PROJECT NO. 55566

**GENERATION INTERCONNECTION
ALLOWANCE**

**COMMENTS OF APEX CLEAN ENERGY AND CYPRESS CREEK RENEWABLES ON
PROPOSAL FOR PUBLICATION OF AMENDMENTS TO 16 TAC §25.195**

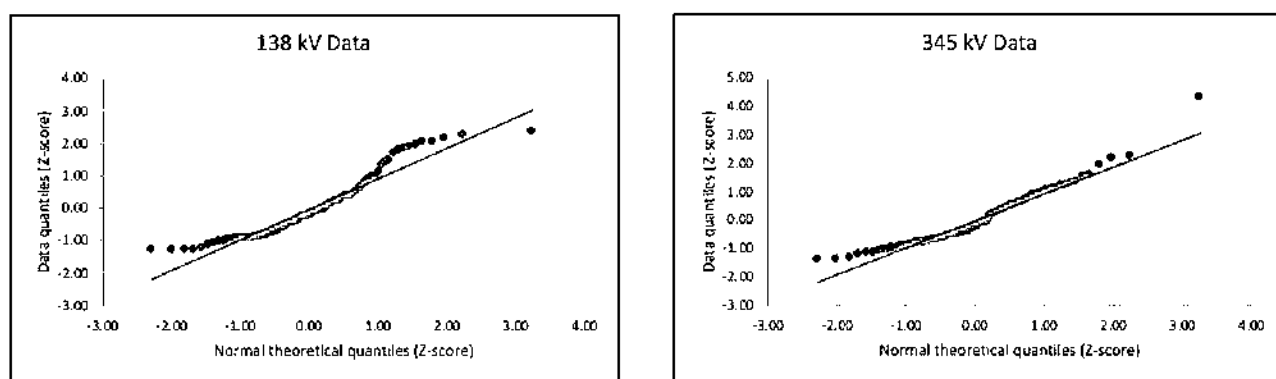
To finance projects, generators cannot be subject to undefined obligations to assume costs needed to interconnect the generation resource as determined by the TSP and ERCOT whenever they arise. While the costs of particular materials, equipment, or construction may fluctuate, the technical requirements and equipment needed to interconnect the generation resource subject to the cost allowance should be established upon completion of the Full Interconnection Study (FIS) process and not in other regional studies regularly performed by the TSP or ERCOT that assess cumulative impacts of multiple new loads and resource additions on system stability or other system dynamics that, by definition, benefit other transmission level customers and the system as a whole. Apex and Cypress Creek recommend clarifications to the language of proposed §25.195(f)(3) as follows:

- (3) If the SGIA between a generation resource and TSP is executed after December 31, 2025, then the interconnecting generation resource is responsible for all costs of installing interconnection facilities ~~that are incurred by the TSP~~ necessary to interconnect the generation resource identified by the TSP in the Full Interconnection Study and contained in the fully executed SGIA that exceed the allowance established in accordance with this paragraph. The TSP is responsible for the costs of installing any transmission system upgrades deemed necessary by the TSP and ERCOT that are made concurrently with the installation of the interconnection facilities.
